<b>SUNDRY NOTICES AND REPORTS ON WELLS</b> (DO NOT USE THIS FORM FOR PROPOSALS TO DRILL OR TO DEEPEN OR PLUG BACK TO A DIFFERENT RESERVOIR. USE "APPLICATION FOR PERMIT" (FORM C-101) FOR SUCH PROPOSALS.)		WELL API NO. <b>30-045-38313</b>

2. Name of Operator <b>SIMCOE LLC</b>		6. State Oil & Gas Lease No. <b>NMNM03358</b>
3. Address of Operator <b>1199 MAIN AVE., STE #101, DURANGO, CO 81301</b>		7. Lease Name or Unit Agreement Name <b>NORTHEAST BLANCO UNIT</b>

4. Well Location Unit Letter <b>D</b> : <b>751</b> feet from the <b>NORTH</b> line and <b>724</b> feet from the <b>WEST</b> line Section <b>12</b> Township <b>31N</b> Range <b>7W</b> NMPM County <b>SAN JUAN</b>		8. Well Number <b>003H</b>

SIMCOE LLC is requesting to extend the Surface Casing to 3,600' TVD.

## Wellbore Schematic

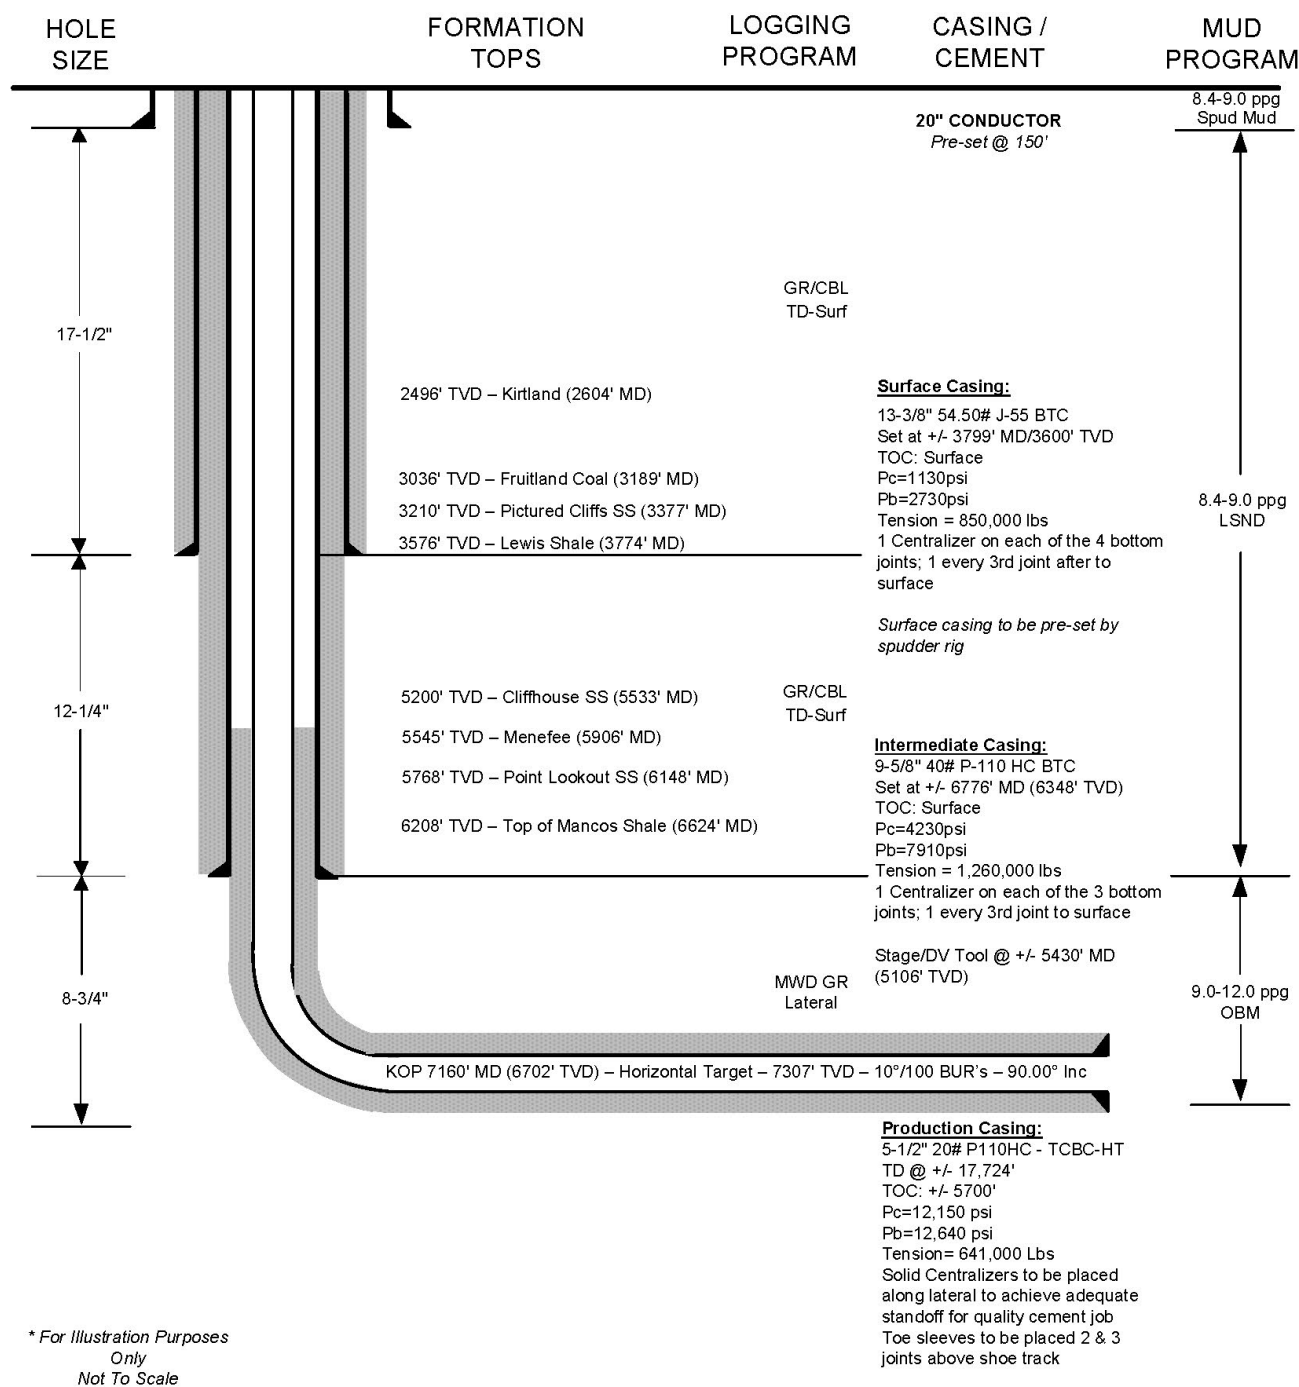
Revised Surface Casing Program:

Casing size 13-3/8" set at ±3600' TVD (roughly 25' into the Lewis Shale); conventional cement job (1 stage), circulated to surface.

To mitigate expected lost circulation problems in previously designed long (±5500' MD), deviated intermediate casing section; extreme lost circulation encountered both in offset operator's wells in addition to historic BP NEBU wells; will allow depleted intervals in Kirtland, Fruitland Coal, & Pictured Cliffs to be isolated behind pipe (surface casing) before drilling into the known depleted intervals in the Mesa Verde section; setting surface casing deeper (into the Lewis) allows for improved drilling efficiency & also increases the safety of drilling operations through these depleted sections.

1. Surface casing must be always at a minimum half fluid fill.

## Wellbore Schematic

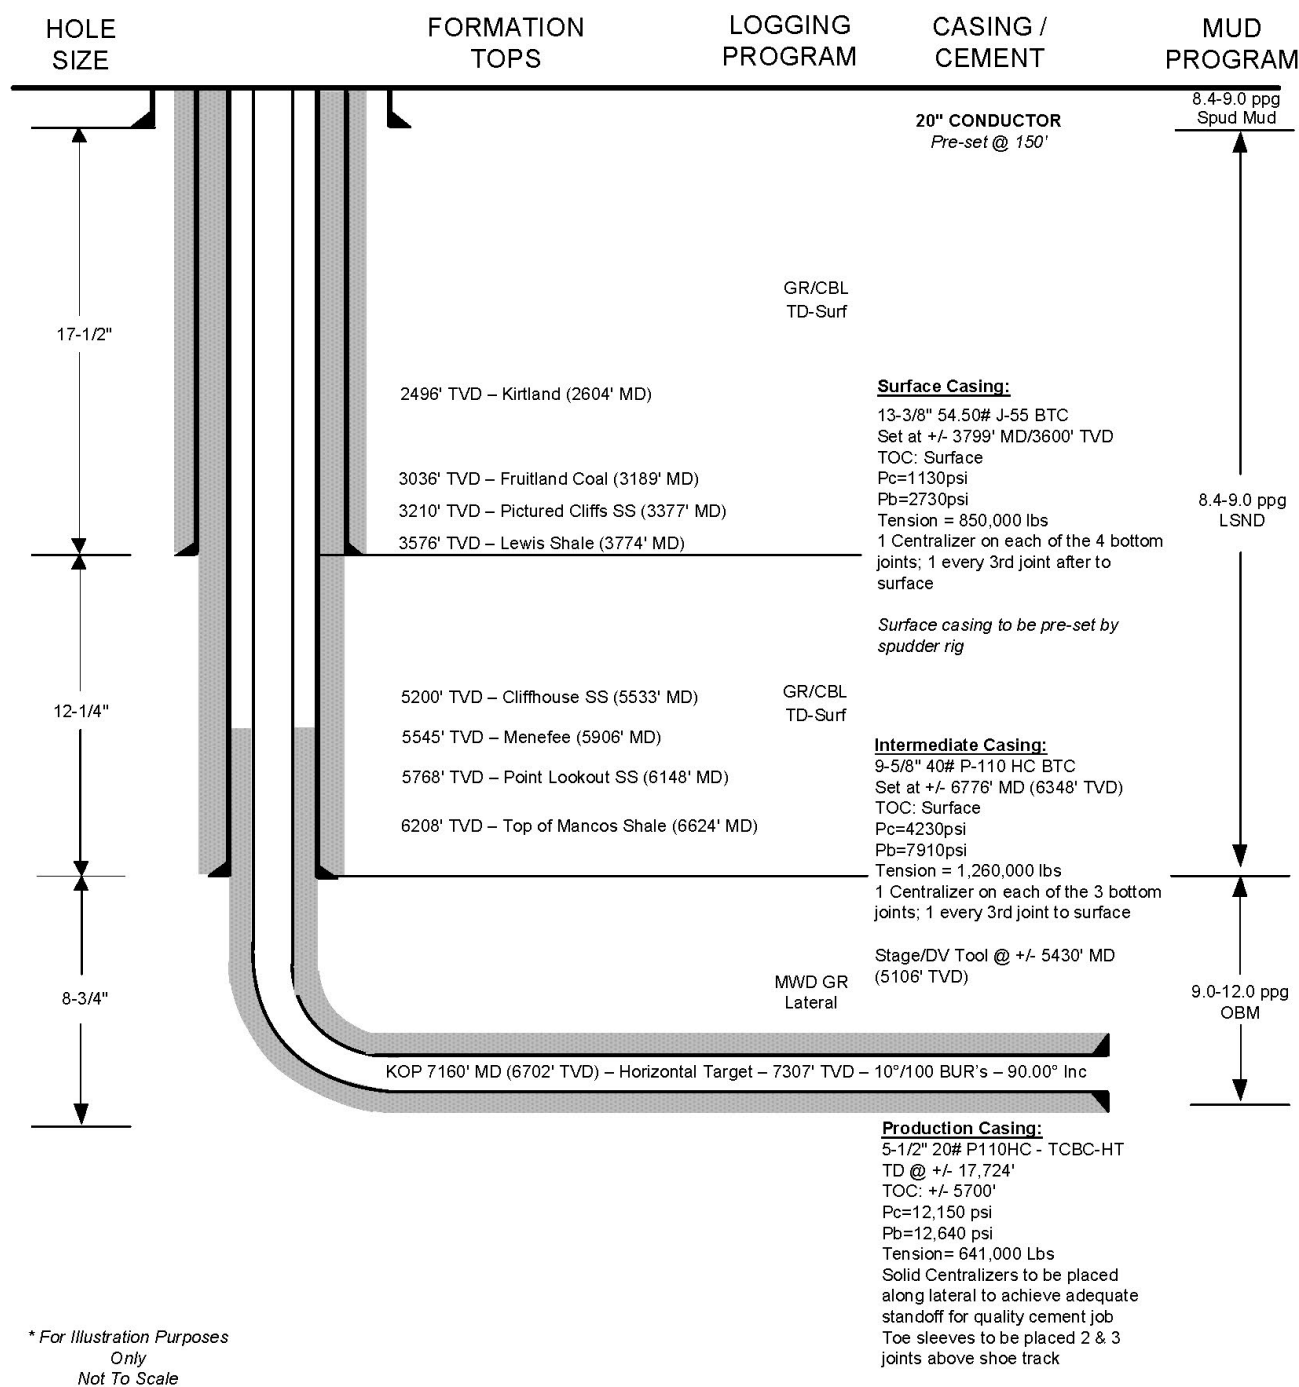
Reasons for setting deeper surface casing.

- to mitigate expected lost circulation problems in previously designed long (5500 MD), deviated intermediate casing section
- extreme lost circulation encountered both in offset operators wells in addition to historic BP NEBU wells
- will allow depleted intervals in Kirtland, Fruitland Coal, & Pictured Cliffs to be isolated behind pipe (surface casing) before drilling into the known depleted intervals in the Mesa Verde section
- setting surface casing deeper (into the Lewis) allows for improved drilling efficiency & also increases the safety of drilling operations through these depleted sections

1. Surface casing must be always at a minimum half fluid fill.
